**HISTORIC PRESERVATION REVIEW BOARD
STAFF REPORT AND RECOMMENDATION**

Landmark/District: **Foggy Bottom Historic District** (x) Agenda
 Address: **900 25th Street NW**

Meeting Date: **December 15, 2022** (x) Alteration
 Case Number: **23-093** (x) Permit

The applicants, property owners Chad Navarrete and Denise Heuchert, request Board review of a concept application to build a basement-entrance stair along the side of a house, in public space.

A detail from the 1960 Baist map showing the twelve-foot-wide parking strip (in pale green) along I Street.

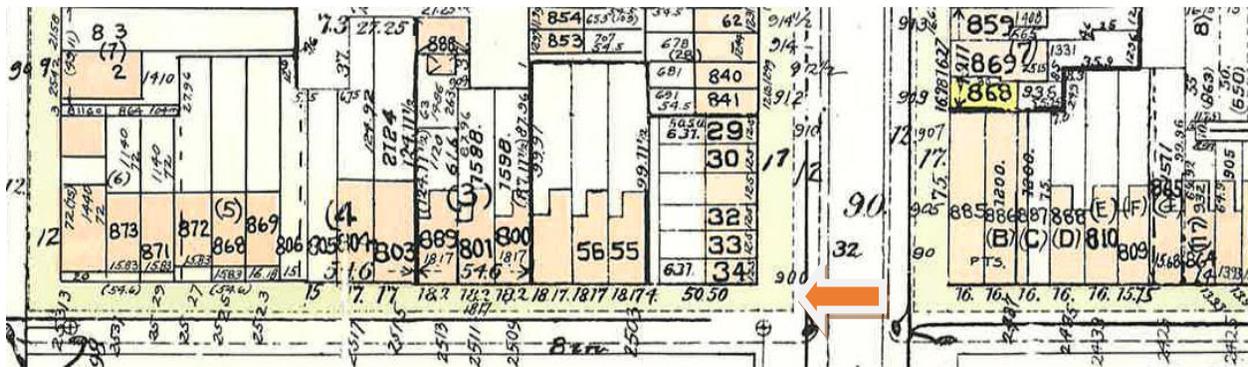
The property is the south end unit on a six-unit brick row erected in 1880. Its single, shallow side yard is enclosed by a low fence, but it is entirely within the I Street right-of-way. Staff had recommended that the stair be mostly relocated to the rear yard, even if it had to be decked over there and still extend a bit into the right-of-way (on a straight run or in an L configuration), to minimize the projection of such feature into the public space, to minimize the removal of planted areas, and to minimize the exposure of the building’s foundation. This portion of the “parking” strip should be greened up—consistent with the intent of the Parking Act of 1871—rather than permanently excavated and hardscaped. As proposed, it would remove a couple of birch trees and some foundation shrubs. Much of the remaining area would have to be paved: first, for a walk to reach the stairs, and then, presumably another walk around the stairs to the rear yard, neither of which are depicted in the site plan.

The design guidelines principally contemplate the introduction of entrances from public space into the proper front of a house. “Individually, these public space front yards are for the use and enjoyment of owners whose property abuts them; collectively, they form a linear, park-like green space that runs through the city’s residential neighborhoods.” Yet, while this is not the location of the front door, it is still a street front, one segment of the continuous front-yard parking strip through the two blocks of I Street within the historic district. It is not equivalent to a side-yard areaway sandwiched between two houses. The proposal is more extensive than what is entertained in front yards, where the guidelines strongly discourage stairways at houses nearly on grade because of their necessary run.

Board decisions do not carry the weight of judicial precedent, but the Board is relied upon to render decisions that are reasonably consistent from project to project that are similarly situated. It would be difficult hereafter to distinguish this case from the many other instances of “parking” strips at the street corners of Foggy Bottom. Indeed, it is conceivable that there ultimately could be four such stairs at this intersection alone.
